Technical Summary Report

(by the Joint Agency Review Team)

Proposed Expansion to the Burlington Quarry

June 2023

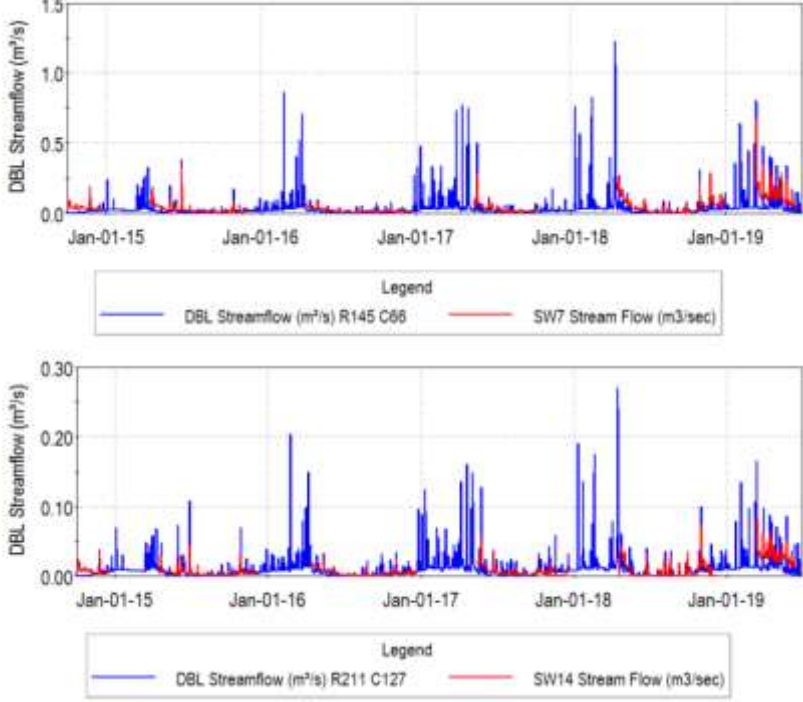
126.	<p>As per Figure 18.20 it appears that the cells with increased vertical hydraulic conductivity are not present within some 100.0 meters of the edge of escarpment and within the Medad valley – please explain.</p> <p>Based on the retained consultant’s experience the distribution of vertical fractures near the escarpment tends to be higher (halo effect).</p>	<p>Each cell in the model was assigned a random number from 0 to 1. Five percent of the cells (those with a random number between 0.95 and 1, for example) were assigned a different VKA value. There was no consideration of proximity to the Niagara Escarpment so some cells must have higher VKA in proximity to the Escarpment.</p> <p>Incorporation of an enhanced fracturing halo zone was tested early in the model development but was not found to improve results.</p>	<p>Neither Figure 18.20 nor 18.21 show any cells within at least 100 m along the east boundary of the escarpment.</p> <p>Higher hydraulic conductivities along the fringe of the escarpment may have impact on the groundwater levels, shift the groundwater divide closer to the quarry, etc.</p> <p>The last statement about testing the halo zone which resulted in no improvement of the results is rather subjective. To represent groundwater conditions, the model should be built using available data to a maximum extent possible.</p>	<p>The cells were distributed randomly.</p> <p>It is not subjective; we compared results to interpolated maps of water levels and did not achieve a better match with the halo, indicating that the halo effect, if present, is not as pronounced as in other study areas.</p>	<p>On January 1, 2023, Ontario Regulation 596/22 came into effect. As a result, technical review services for planning and development applications previously provided by Conservation Halton (CH) under Memorandums of Understanding with municipalities (e.g., technical reviews related to natural heritage and select aspects of stormwater management) can no longer be provided. As such, we defer this comment to the other JART members to confirm whether it has been addressed.</p> <p>Norbert Woerns has reviewed Nelson's response and provided the following JART response: (modelling</p>

<div>comment) CHRIS NEVILLE: UNRESOLVED. The Applicant responses confirm that no physical consideration was given to the specification of model cells with increased vertical hydraulic conductivities. As indicated in the Applicant response, no consideration was given to the proximity to the Niagara Escarpment.</div>

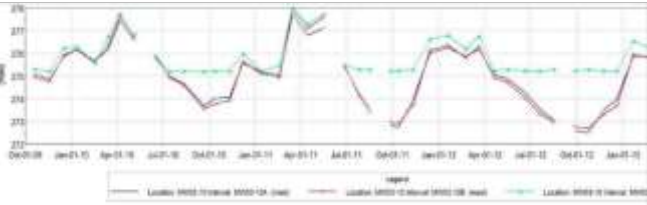
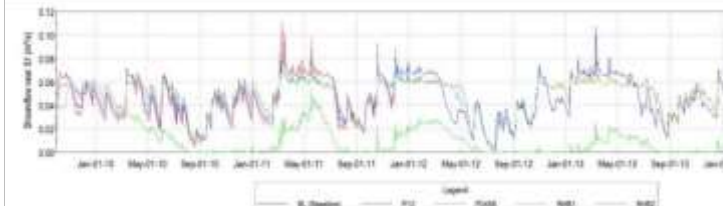
173.	Figure 6.19, Simulated and observed flow at SW10B for WY2019 - While the match of observed streamflow to the GSFLOW simulated flows is very good for 2019, the match for Fall 2018 is weak. Further discussion is required and refinements to the calibration may be required.	Over the longer period of record, the model performs well, although there is not much winter/early spring data for comparison other than 2019. We have noticed a bit of a lag in the fall recovery. This is likely due to the need to bring soils up to field capacity before groundwater discharge or Dunnian flow occurs. In the field, the values of soil storage capacity will likely vary, with some areas contributing flow earlier than others. Randomizing the storage capacity values within each class might help but was not implemented in this model. The quality of the data also appears to get better with time. 	Not addressed It appears that the soil layer in the model does not best fit the natural data and that field capacity and soil capacity should be revisited.	We believe that we have achieved a good match except to mechanisms that allow for contribution to groundwater recharge and overland flow before the entire soil reservoir has reached field capacity. In our response to MNDMNRF (Earthfx, March 2021) we provided extensive comparison between observed and simulated shallow model response. Overall, the calibration to the minipiezometers was excellent, in both response timing and to monitors across the wide study area.	On January 1, 2023, Ontario Regulation 596/22 came into effect. As a result, technical review services for planning and development applications previously provided by Conservation Halton (CH) under Memorandums of Understanding with municipalities (e.g., technical reviews related to natural heritage and select aspects of stormwater management) can no longer be provided. As such, we defer this comment to the other JART members to confirm whether it has been addressed. Norbert Woerns has reviewed Nelson's response and provided the following JART response: (modelling comment) CHRIS NEVILLE: UNRESOLVED. The Applicant Response, “We believe that we have achieved a good match except to mechanisms that allow for contribution to groundwater recharge and overland flow before the entire soil reservoir has reached field capacity” implies that the "except" is not important. Referring to the original comment, the match to Fall 2018 condition is relatively poor. Contrary to what is suggested in the Applicant Response of June 2022, many of the plots included in the responses to the MNDMNRF comments do not include comparisons between observed and shallow model responses. Instead, observed water levels are shown along with simulated soil moisture fractions (see for example Figure 3 and 16 subsequent figures).

174.	To validate the GSFLOW model, hydrographs illustrating simulated and observed flows should be presented at a surface water monitoring location on each tributary.	Of the 20 surface water gauges available for GSFLOW calibration, 10 were located more than 3.5 km from the site, had data only for 2018 and 2019, and, of these, seven were outside the model boundary. We found that no change in simulated flow occurs at or close to these locations. SW15 is on the opposite (north) side of the quarry and far from the expansion areas. SW7 and SW14 were discussed in great detail, so it was only SW2 which was omitted and the effects of the quarry extension were better seen in the upstream gauges.	Not addressed, comment stands. SW7 and SW14 are not discussed in this section, only SW9 and SW10 are. Further, graphs are not provided in Appendix E for SW7 or SW14. Graphs are provided for SW9, SW10B, SW29, and SW2. SW2 was not omitted, but shows poor correlation and must be included as the only gauge downstream of the karst feature on Willoughby Tributary. Please provide hydrographs for all flow monitoring stations shown on Figure 19.4 in Appendix E.	We presented all available data as hydrographs in our meeting with JART team members. The two hydrographs below were part of the presentation. 	On January 1, 2023, Ontario Regulation 596/22 came into effect. As a result, technical review services for planning and development applications previously provided by Conservation Halton (CH) under Memorandums of Understanding with municipalities (e.g., technical reviews related to natural heritage and select aspects of stormwater management) can no longer be provided. As such, we defer this comment to the other JART members to confirm whether it has been addressed. Norbert Woerns has reviewed Nelson's response and provided the following JART response: (modelling comment) CHRIS NEVILLE: PARTIALLY ADDRESSED. The Applicant Response of June 2022 includes hydrographs for SW7 and SW14. Hydrographs have not been included for SW9, SW10B and SW29. Further discussion of the implications of the poor match to the data from SW2 is required, as this is the only gauge downstream of the karst feature on Willoughby Tributary.

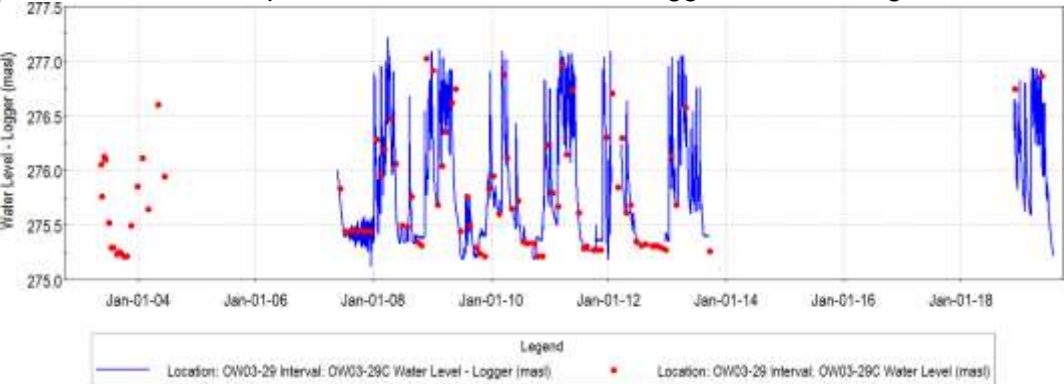
69. Monitoring locations for which results from the GSFLOW model calibration are reported – The Level 1/2 Hydrogeological and Hydrological Impact Assessment has been reviewed and it is noted that: The GSFLOW model has been calibrated for the five (5) year period, WY2010-WY2014 (October 2009 to September 2014); and The summary of the number of wells for which GSFLOW simulation results are reported in the Level 1/2 report is presented on Table 1. Comparisons between observations and simulation results are presented for 39 locations.

Figure 5.12: Water levels recorded in Monitoring Well OW03-14 (175 m to 40 m from

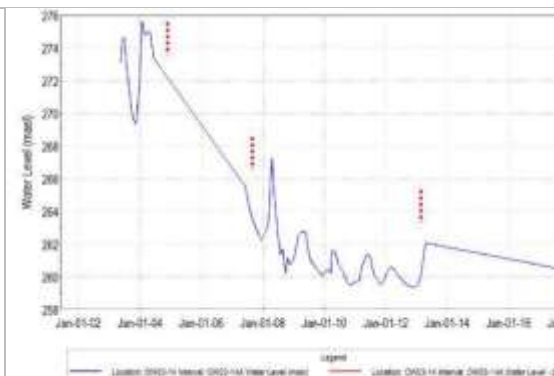
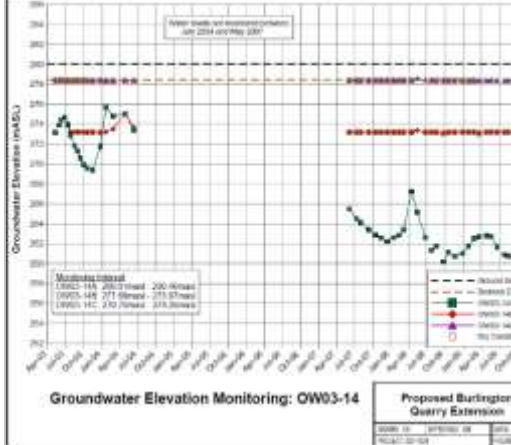
129.	<div>It is suggested in the second paragraph of this section, based on Figure 5.12 which presents water levels in OW03-14C that quarry influence is less than 200.0 meters from the quarry face. Based on other monitoring well results it seems that this may be true for this location only suggesting that the aquifer is not uniform, and which puts in question the use of uniform hydraulic conductivity values in model layers.</div> <div>Please reconsider the use of uniform hydraulic conductivity values in the model.</div>	<div>This area is the most monitored in the study area and it seemed reasonable that, without observations to the contrary, relatively consistent aquifer properties should be adopted.</div> <div>As noted earlier, as part of model development we used the pilot point technique in conjunction with PEST to create an interpolated hydraulic conductivity field. In the end, we found no consistent pattern and went back to uniform property assignment.</div>	<div>As identified on various other figures, the quarry impacts are identified farther away from quarry face. The response in OW03-14 (Figure 5.12) suggests that the aquifer is not uniform.</div>	<div>The quarry impact, in that particular section of the report, was related to the dropping of heads to close to the elevation of the quarry floor. In more generalized discussions of the extent of impacts (elsewhere in the report), the effects refer to o a noticeable decline in water levels, and that occurs over larger distances (about 800 m). It is not related to local hydraulic conductivity variations.</div>	<div>On January 1, 2023, Ontario Regulation 596/22 came into effect. As a result, technical review services for planning and development applications previously provided by Conservation Halton (CH) under Memorandums of Understanding with municipalities (e.g., technical reviews related to natural heritage and select aspects of stormwater management) can no longer be provided. As such, we defer this comment to the other JART members to confirm whether it has been addressed.</div> <div>Norbert Woerns has reviewed Nelson's response and provided the following JART response: (modelling comment) CHRIS NEVILLE: UNRESOLVED. It is not clear from the Applicant responses what the extent of the quarry influence might be, and whether the extent might vary spatially. Referring to Figure 5.12, it is inferred that the influence of the quarry extends less than 200 m from the quarry face. However, it the Application Response of June 2022 it is indicated that the extent of “noticeable decline in water levels” occurs over larger distances (about 800 m).</div>
